## Metro Vancouver's Cycling Advocates

May 24, 2011

**Re: Low Level Road Project**

**Figure 1. West to East profile existing vs. proposed.**

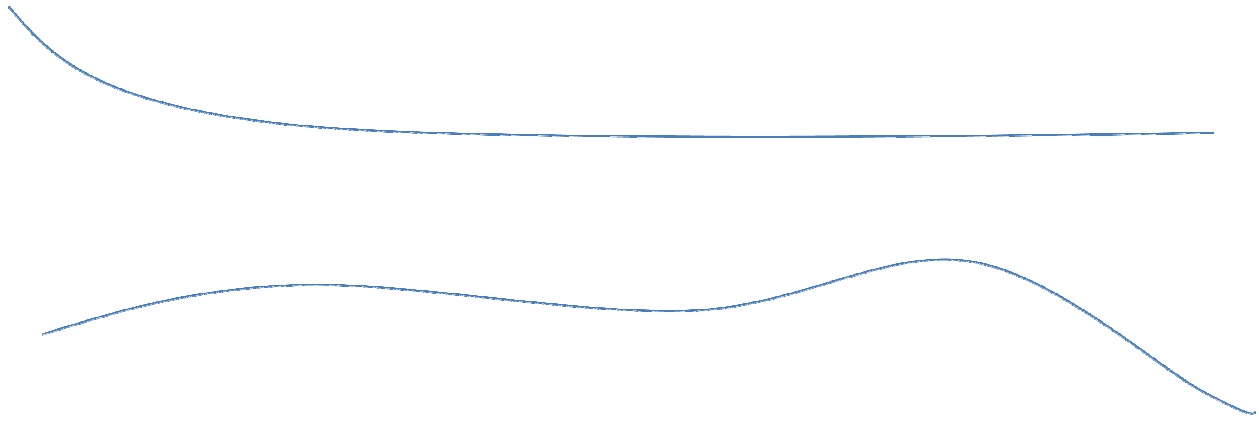
A review of drawings for the project leads us to believe that two new hills will be introduced where none existed. Currently, the Low Level Road is the only flat east-west connection in the area. On every other route (3rd Street, Keith Road or trails) cyclists must climb very steep hills. Figure 1. below shows a rough comparison of the profile for the existing and proposed Low- Level route moving from West to East.

In the drawings we have seen recently (May 17, 2011) the grades have been flattened significantly and the steepest grade would be around 6.4%. This is a definite improvement over the previously proposed 8%. However hills with a grade of 5% will serve as barriers to some cyclists and to people in non-motorized wheel chairs. We recommend grades of no steeper than 4%. To achieve this, the project would need to start further east.

**Figure 2. Example of a physical barrier that does not prevent emergency vehicle access**

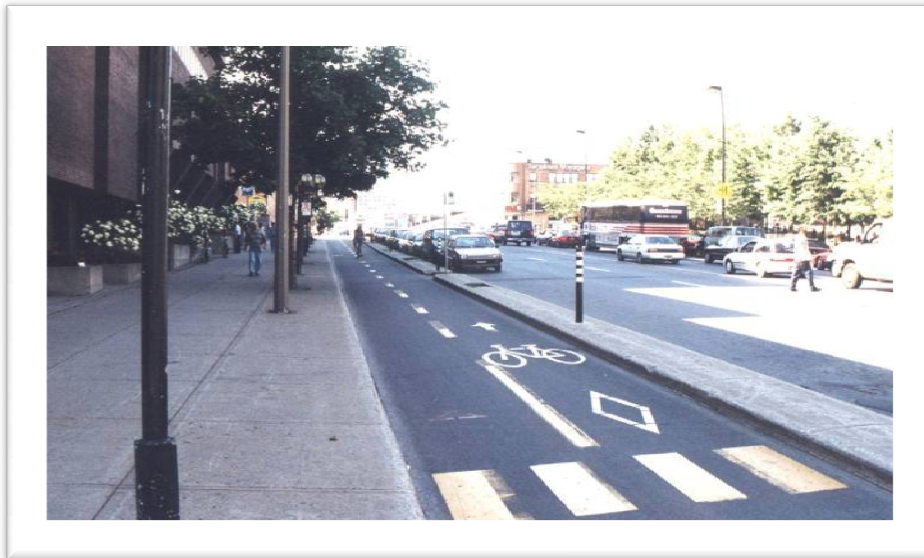
The current design calls for a 2 m wide at-grade cycling lane. To improve safety, this design should incorporate physical barriers between cyclists and vehicular flow. Permanent barriers are preferred over painted lines. There are barriers that provide a visual cue and physical deterrent that discourage vehicles from penetrating into cycling lanes and at the same time allow emergency vehicle access, which was the main reason given to VACC by the project team for not considering physical barriers. See Figures 2 and 3 below for examples of this kind of barrier.

**Figure 5. Trees or low growing shrubs can offer a natural separation barrier**

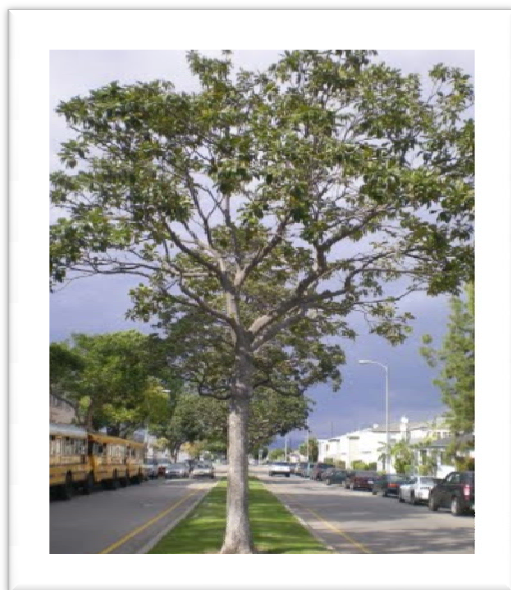
- The VACC suggests that living trees or lower growing shrubs might form a natural barrier between cyclists and motorists. These could be spaced far enough apart to accommodate emergency vehicle access. This approach (see Figure 5) would serve the triple purpose of bringing nature into an otherwise sterile landscape, separating cyclists from traffic and reducing vehicle speed.

**Figure 6. New Connector to Spirit Trail in Moodyville**

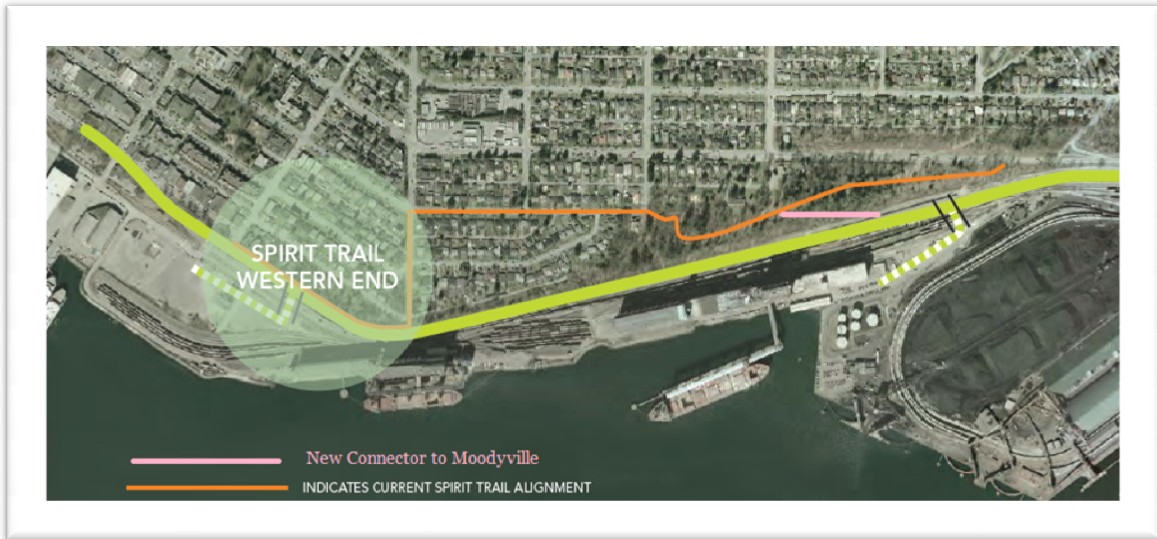
The Low-Level road is effectively sealed from any Northerly penetration. Cyclists who wish to travel North to Moodyville might be better served to ride the new Low-Level road and take a transition path up to the Spirit Trail. The alternative is to ride up 3<sup>rd</sup> Street, which is very steep. The VACC recommends the project office consider implementing a connector trail to the Spirit Trail to the North into Moodyville as in Figure 6.
